Our Ref: 25/02446/CDA

**Confirmation that all conditions were approved, in relation to Listed Building consent 09/01116/1LBC granted on 26.08.2009.  
Chandlers Cottage, Drivers End, Codicote, Hitchin, Hertfordshire SG4 8TR**

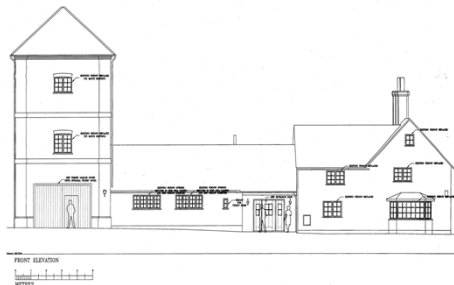
Condition 4 states that excluding the windows in the water tower, all other proposed windows shall be constructed based on the Barnsdale C2 timber flush casement window range with 21mm glazing bars. From the photos provided including the close-ups, these appear to show the Barnsdale C2 timber window type and I am satisfied that the white external finish of these windows also satisfies Condition 6 for these windows. However, the photos do not address all non-water tower windows so I can only provide confirmation that the windows that have been photographed are acceptable. Assuming that non-photographed windows are also the 'Barnsdale' type then these will also be considered acceptable.

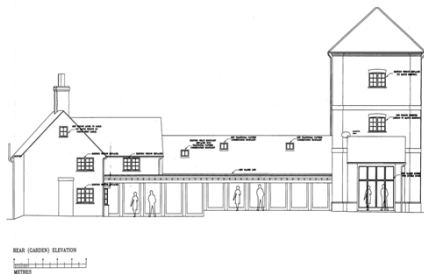
*As stated in the supporting letter dated 10 January 2011, this application follows the applicant's decision not to proceed with the glazed link (for the time being) as permitted under 09/01115/1HH and 09/01116/1LB, but to replace the windows and doors to the area instead and to include the demolition of the conservatory.*

This is noted on the recently submitted photo below right. For clarity, as the glazed link has not been implemented, the reference to the 'posts' in Condition 6 above and the requirements of Condition 7 above have not needed to be met at the current time.
